**TOWN OF NEWBURGH
PLANNING BOARD
TECHNICAL REVIEW COMMENTS**

PROJECT: OPR ASSOCIATES
PROJECT NO.: 17-17
PROJECT LOCATION: SECTION 3 BLOCK 1 LOT 140
REVIEW DATE: 30 JUNE 2017
MEETING DATE: 6 JULY 2017
PROJECT REPRESENTATIVE: MERCURIO, NORTON, TAROLLI & MARSHALL

Re: Job No. 2130-2
Lands of OPR Associates
Tax Map Parcels: 3-1-140
Countryman Lane, Town of Newburgh
Town of Newburgh Project #2017-17
Town of Newburgh Project #2017-18

Site Plan
for
OPR Associates, LLC

RECORD OWNER:
OPR ASSOCIATES, LLC
TAX MAP REFERENCE:
SECTION 3, BLOCK 1, LOTS 140 & 141
DEED REFERENCE:
LIBER 14203, PAGE 1064
TOWN OF NEWBURGH
COUNTY OF ORANGE
STATE OF NEW YORK
DATE: MAY 2017
DRAFTED BY: RTS
PROJECT: 2130-2
SHEET
1 / 3

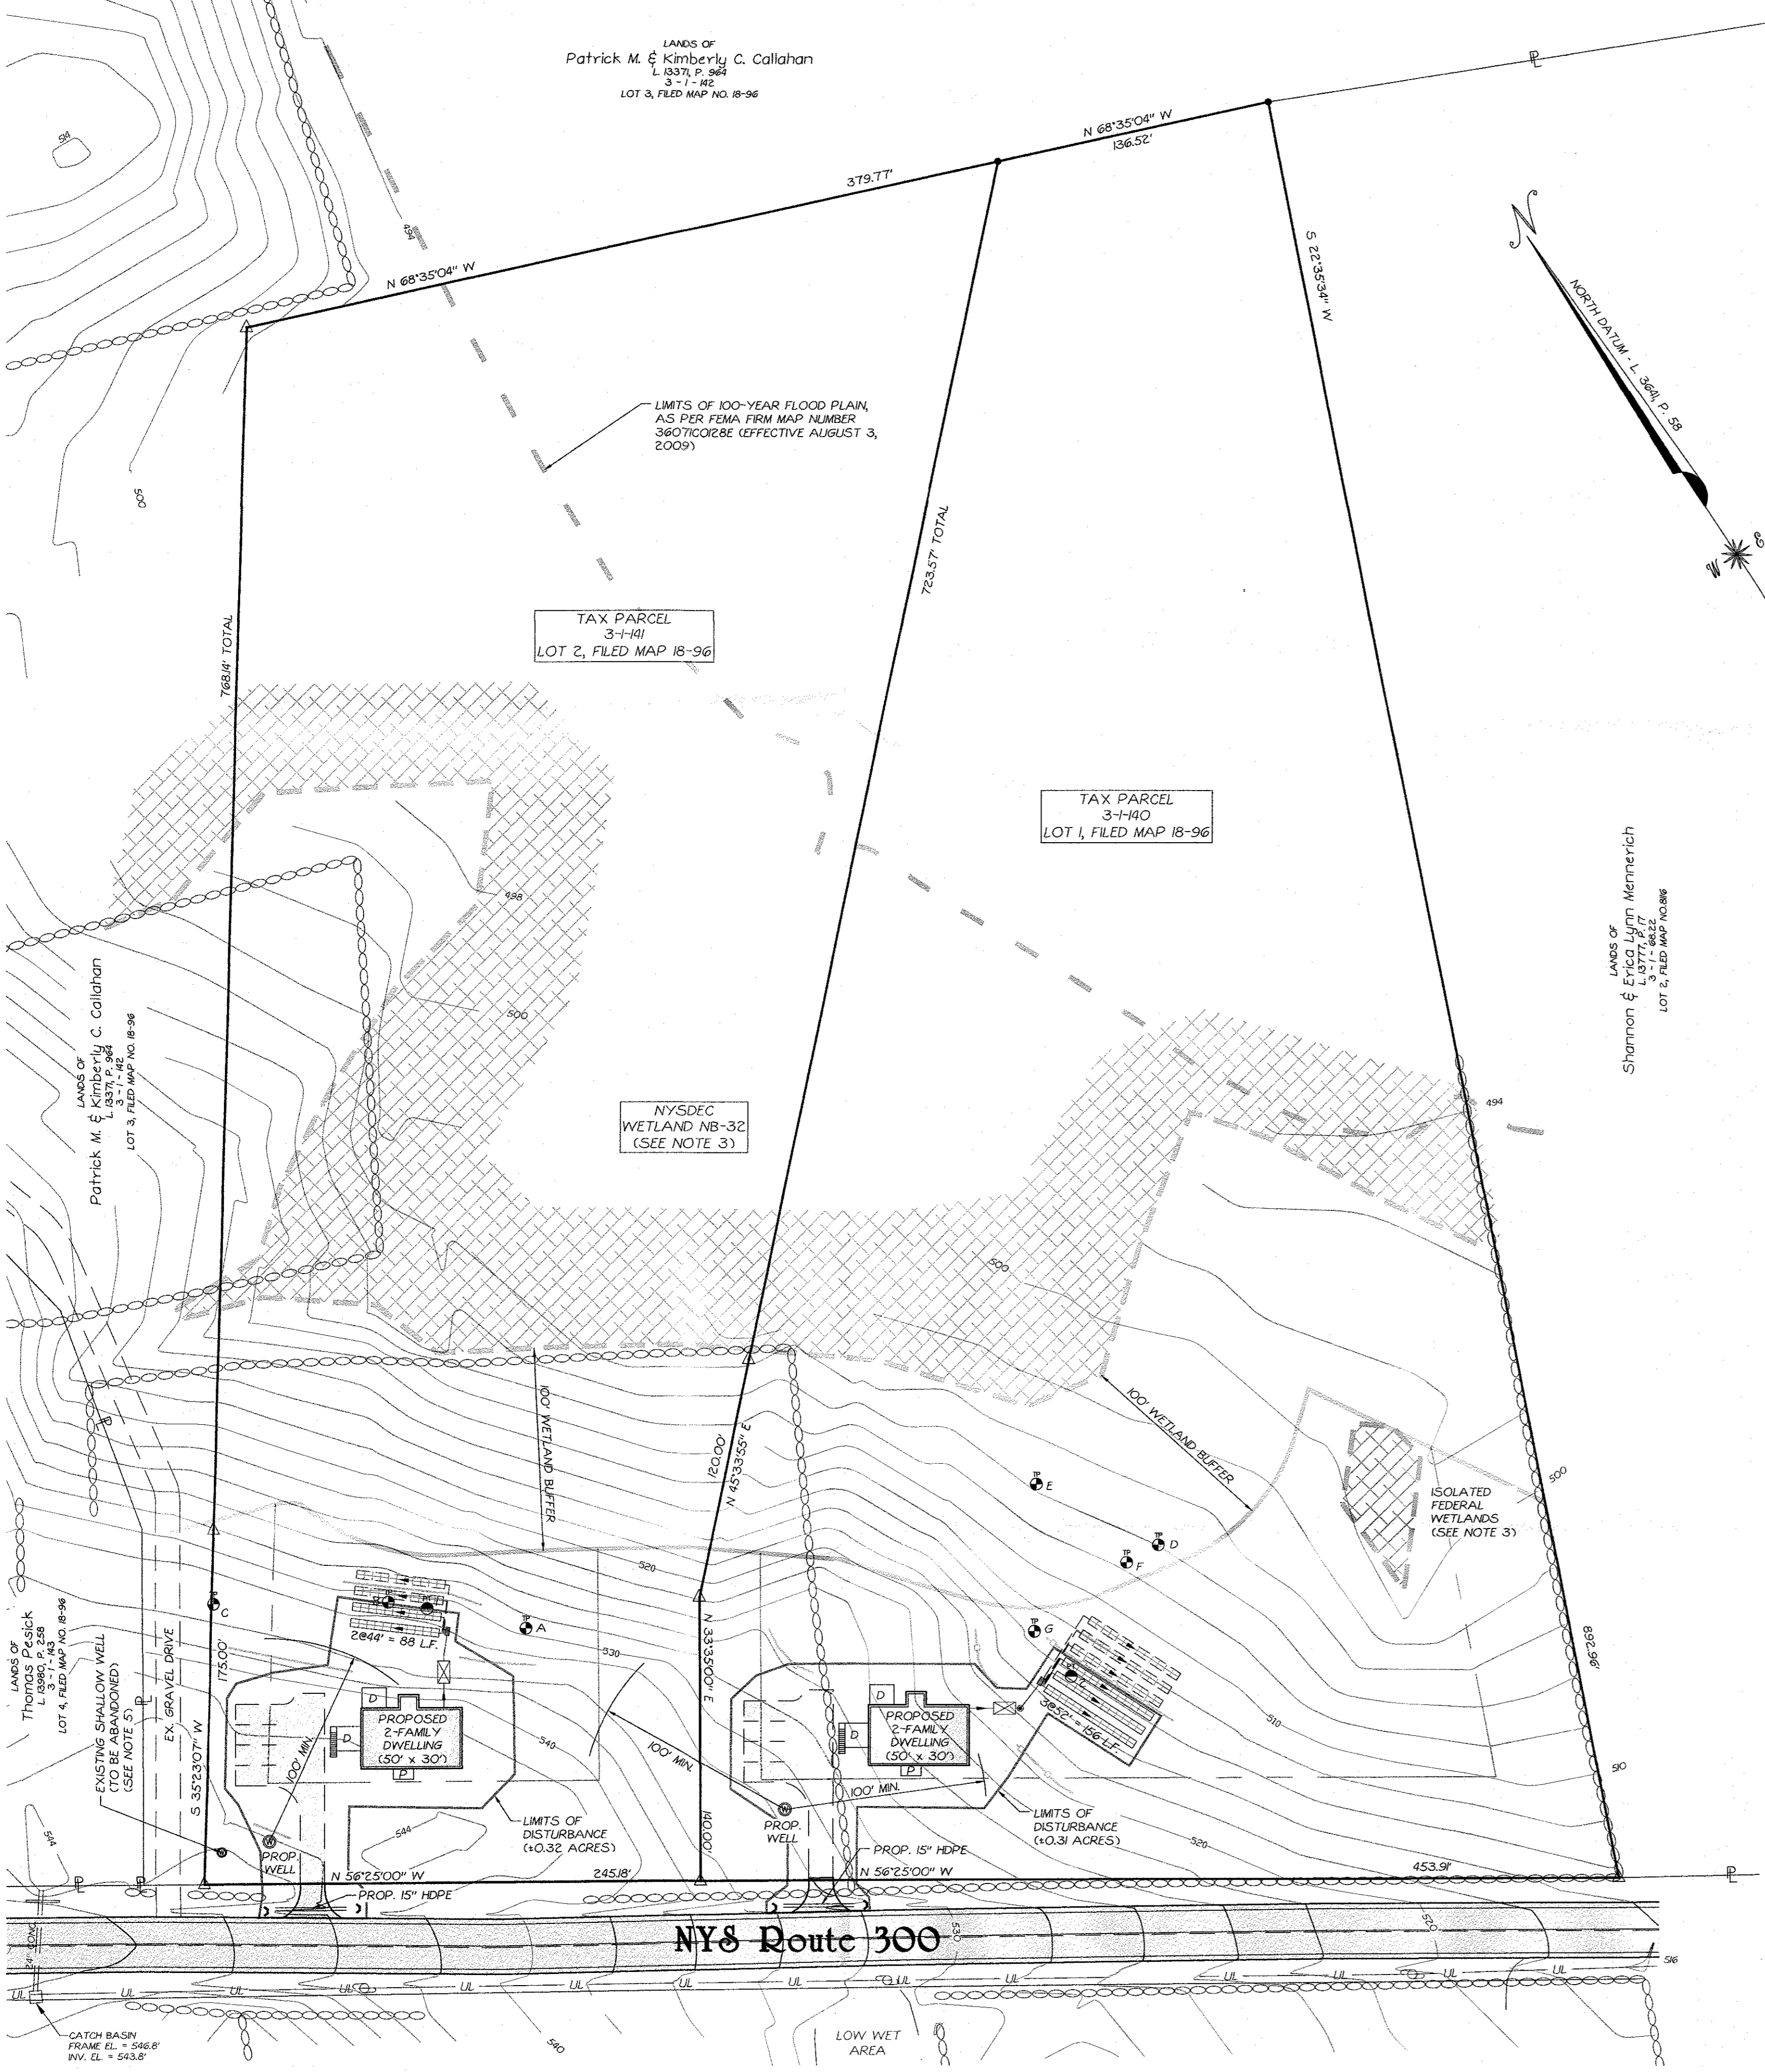
The following responses are based upon a review by Patrick J. Hines dated May 24, 2017 in reference to Town of Newburgh Project #2017-17:

The following responses are based upon a review by Patrick J. Hines dated May 24, 2017 in reference to Town of Newburgh Project #2017-18:

1. Note 3 has been revised to specify the most recent delineation performed by Peter Torgerson on May 5, 2017. The revised plan has been submitted to NYSDEC for approval.

2. The Zoning Legend on sheet 1 of the plan set has been revised to specify the minimum buildable area for the project parcel, no portion of the onsite wetland or buffer have been included in the calculation.

3. The revised site plan has been submitted to NYSDOT for re-approval of the driveway location.
4. The site plan has been revised to more clearly designate the most recent percolation test location.

5. Note 5 has been added to sheet 1 of the plans specifying that the existing shallow well located on Tax Map Parcel 3-1-141 shall be abandoned in accordance with AWWA standards.

6. Survey note 10 has been modified to specify the lot numbers, as requested.
7. Proper notification will be provided for the required public hearing.
